Project	IEEE 802.16e Broadband Wireless Access Working Group < http://ieee802.org/16 >	
Title	Clarification on Figure 70a and Figure 70b	
Date Submitted	2007-01-16	
Source(s)	Giovanni Maggi (Siemens)	giovanni.maggi@icn.siemens.it
Re:	Call for contributions, IEEE P802.16e-2005 Sponsor Ballot	
Abstract	This document clarifies the meaning of * symbol into Figure 70a and Figure 70b and specifies that figure 70b is MS related	
Purpose	Adopt into the current TG working draft	
Notice	This document has been prepared to assist IEEE 802.16. It is offered as a basis for discussion and is not binding on the contributing individual(s) or organization(s). The material in this document is subject to change in form and content after further study. The contributor(s) reserve(s) the right to add, amend or withdraw material contained herein.	
Release	The contributor grants a free, irrevocable license to the IEEE to incorporate material contained in this contribution, and any modifications thereof, in the creation of an IEEE Standards publication; to copyright in the IEEE's name any IEEE Standards publication even though it may include portions of this contribution; and at the IEEE's sole discretion t

Figure 70a – Network entry state-machine BS side.

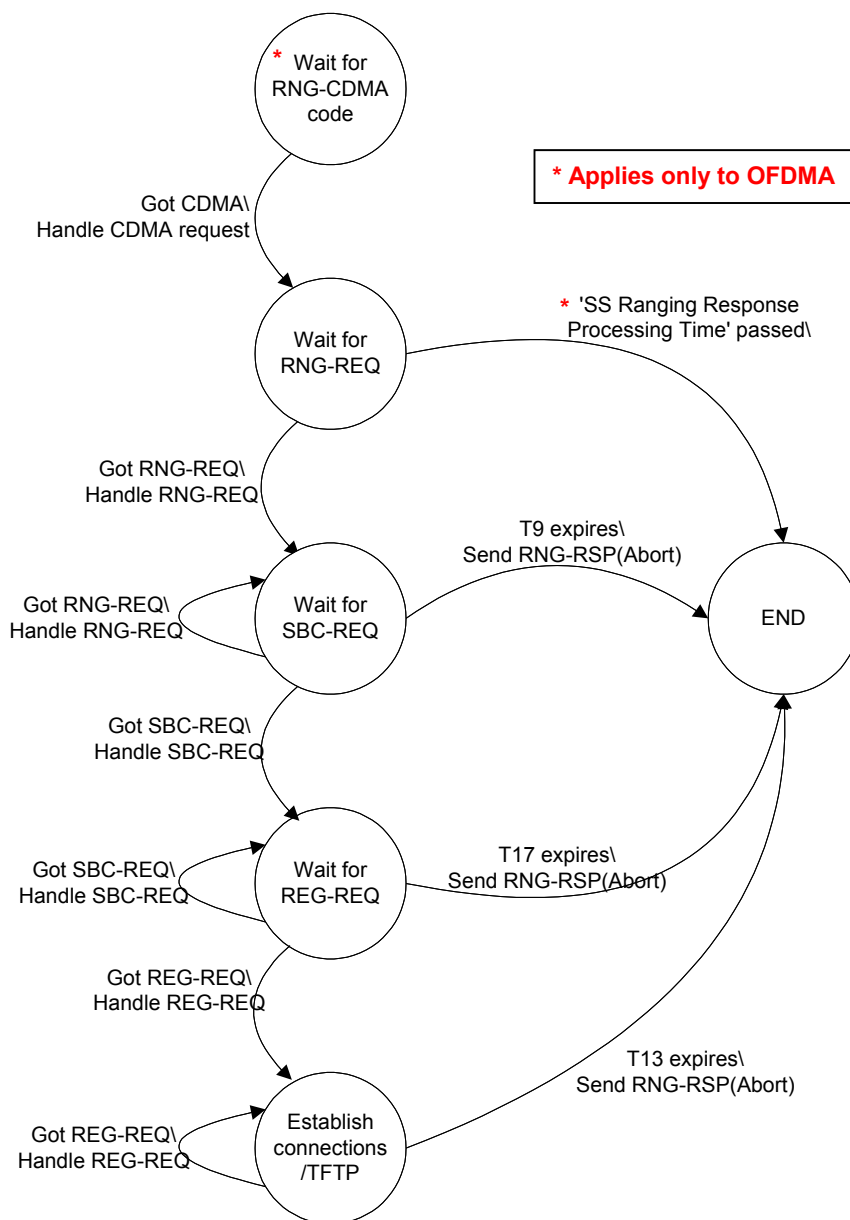
Due to some mistake during previous presentations the sentence “* Apply to OFDMA only” has

been moved closed to the name of the figures, so it seems that figures apply to OFDMA only. Because the figure are valid both for OFDM and OFDMA the sentence “* Apply to OFDMA only” has to be moved away from the name of the figure in order to remove ambiguities.

The sentence “* Apply to OFDMA only” means that the specific transition into the diagram applies to OFDMA only.
